TECHNICAL SERVICE BULLETIN

74-D-9

GEARBOX REMOTE CONTROL LINKAGE
MANUAL TRANSMISSION

MARINA

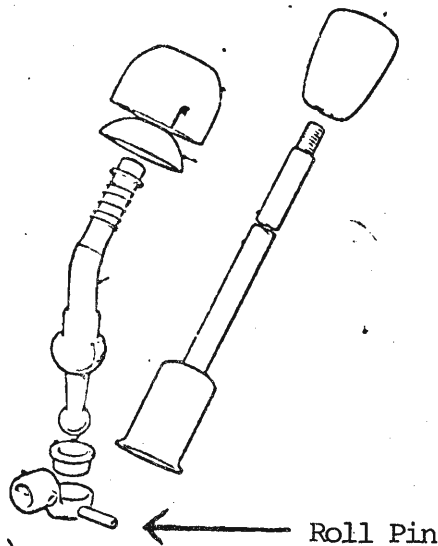
If the roll pin securing the gear lever yoke to the selector shaft is removed in service, it must be discarded and replaced with a new pin. The part number of the pin is RZS 1216.

NOTE: Refitment of the old pin can result in difficult gear engagement or failure of the pin due to movement between the yoke and selector shaft.
